# UNITED STATES PATENT AND TRADEMARK OFFICE

## Office Action Summary

10/786,583

RASMUSSEN ET AL.

Fig. 2A

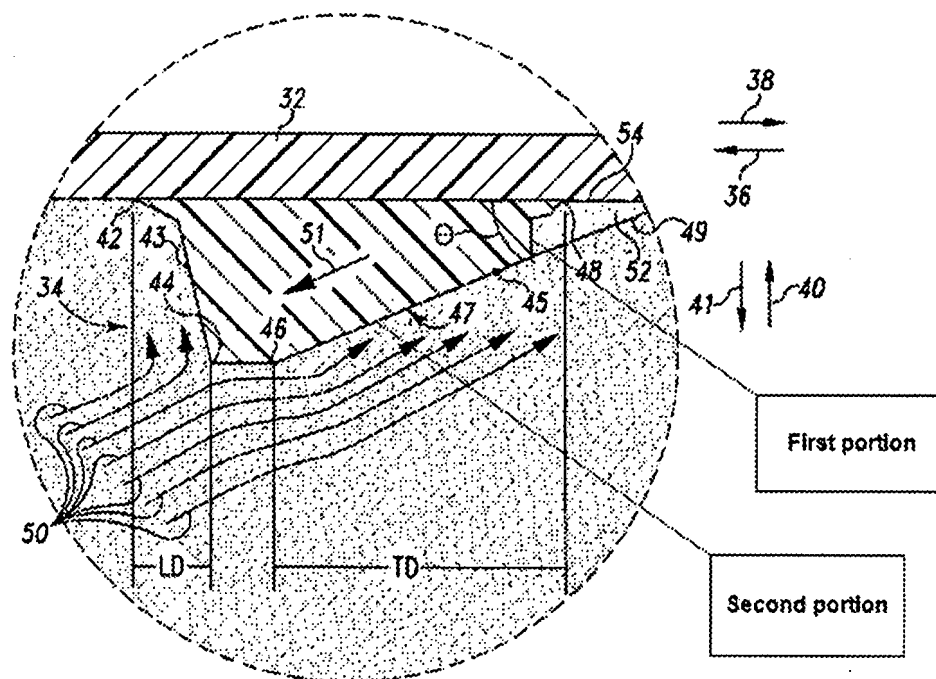
9. Claims 12, 16, 21, 22, and 23 are rejected under 35 U.S.C. 102(b) as being anticipated by Fischer (newly cited).

As shown in figures 2A and 4, the lugs have a lower portion extending away from the track at a first angle, and a second portion extending away at a second angle. See the reproduction of figure 2A below.
